REMARKS

AMENDMENTS TO THE DRAWINGS

Please amend FIGS. 1 and 2(a)-2(d) as shown in red on the attached marked-up drawings. Applicants have also attached replacement drawings. Specifically, FIG. 1 has been amended to delete reference 46, and FIGS. 2(a)-2(d) have been amended to replace reference number 21 with reference number 22.

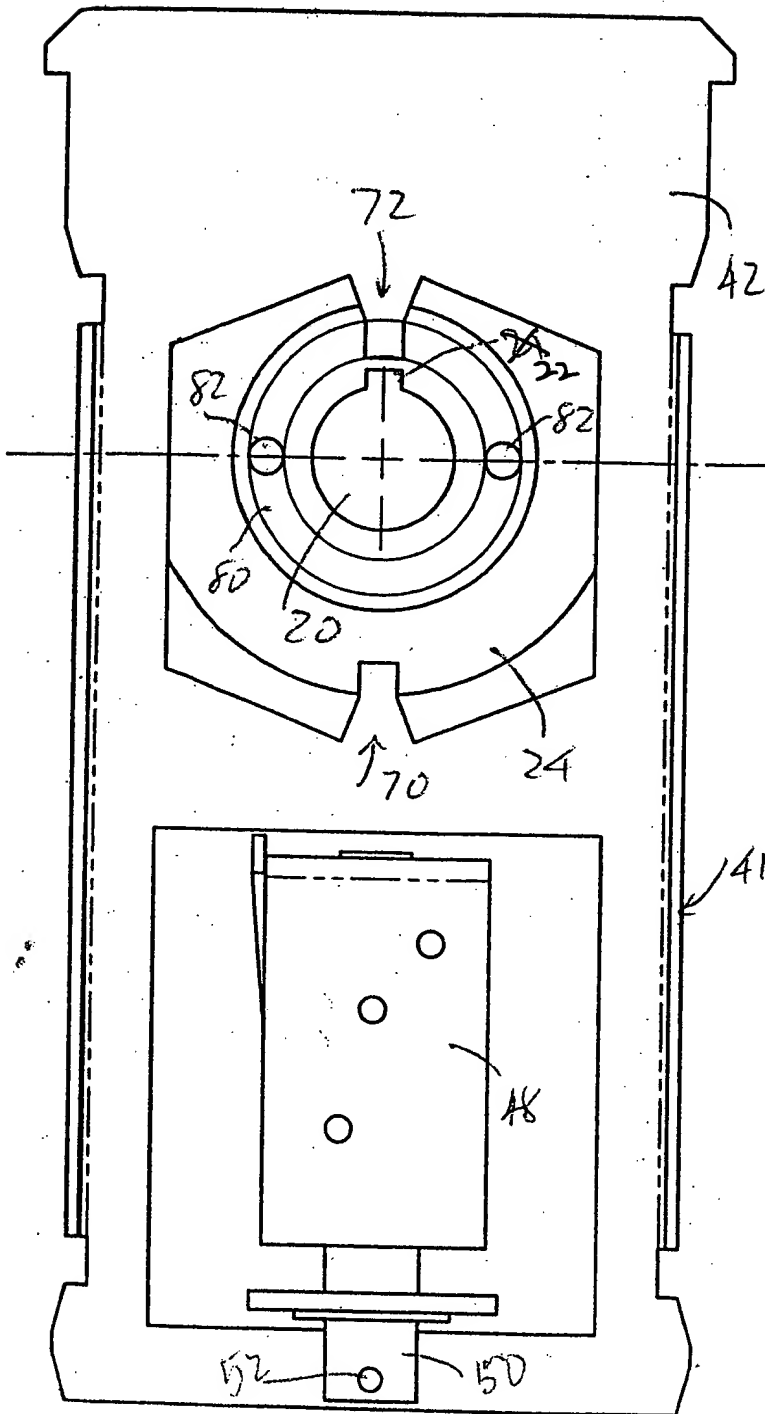
In the February 10, 2006 Office Action the Examiner objected to the drawings as failing to comply with 37 CFR 1.84(p)(5) for having reference numbers 21 and 46 shown in the drawings but not described in the specification. Applicants have deleted reference 46 from FIG. 1 and amended reference 21 to reference number 22 in FIGS. 2(a)-2(d), as shown on the attached marked-up FIGS. 1 and 2(a)-2(d). Applicants have also attached replacement sheets of FIGS. 1 and 2(a)-2(d). Accordingly, Applicants therefore respectfully submit that the Examiner's objection to the drawings is obviated.

FIG 2(a)
LOCK OFF

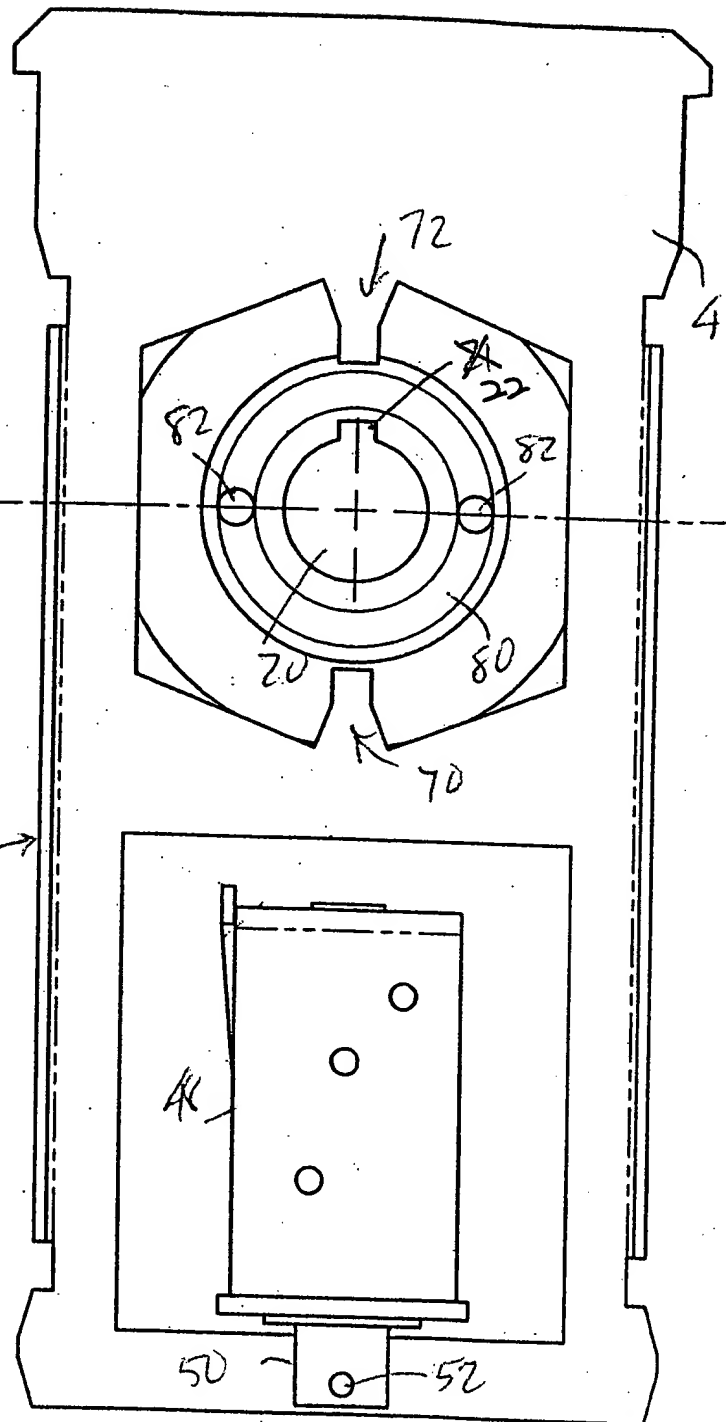
that claims 1, 15, 29, and 43-47 contain limitations reciting that a “slide mounting assembly is moved into a first and a second position, depending if the electrically operated unit is energized or not.” [Office Action, P. 8] The Examiner further alleged that “[a]ccording to Figures 2(a) and 2(b), the element that is displaced is the locking plate 42, not the frame 43.”

Applicants agree that the locking plate may be placed in a first position and in a second position of the slide mounting assembly. Applicants have amended claims 1, 15, 29, and 43-47 to recite that the locking plate, not the slide mounting assembly, may be placed in the first position and in the second position of the slide mounting assembly. Accordingly, Applicants respectfully submit that claims 1, 15, 29, and 43-47 meet the enablement requirement. Claims 2-12, 16-26, and 30-40 depend from claims 1, 15, and 29, respectively, and therefore also meet the enablement requirement. Thus, Applicants submit that the Examiner’s rejection of claims 1-12, 15-26, 29-40, and 43-47 under 35 U.S.C. §112, ¶1 has been traversed, and should be withdrawn.
